PROPOSAL 3-2 (2009)

SCOPE: Sec. 19. 2.1.2 (ASCE-7)

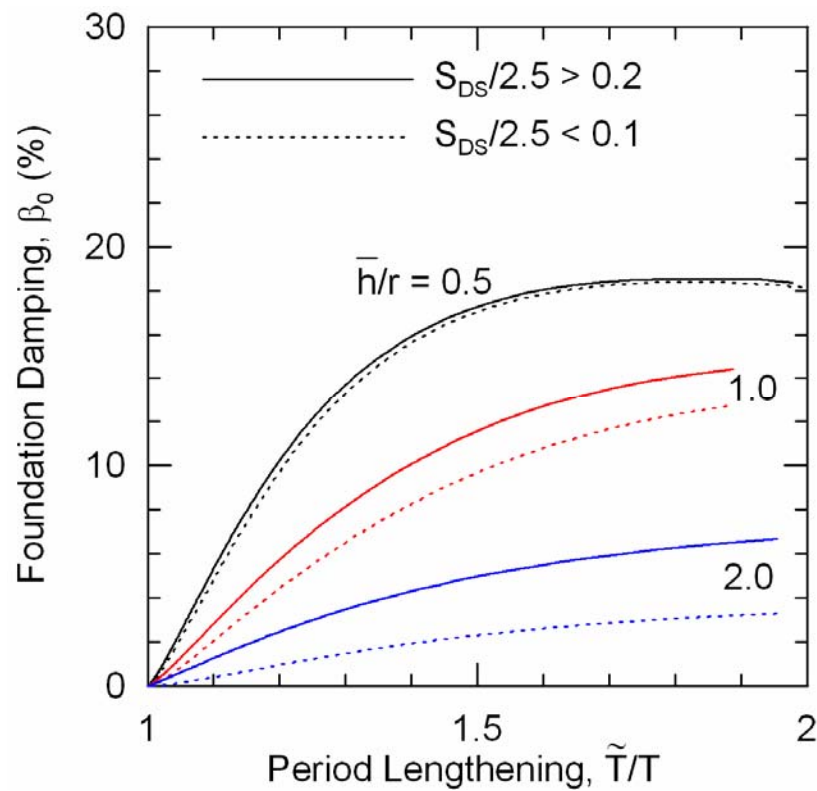
1 Replace Figure 19.2-1 with the following figure:
2

3
4
5
6
7 *The previous figure cannot be reproduced from source articles supposedly used*
8 *to derive it. To correct for this error, the figure shown above was developed in the*
9 *ATC-55 project and is now used in FEMA-440. The correction should now be*
10 *made in the NEHRP Provisions as well.*
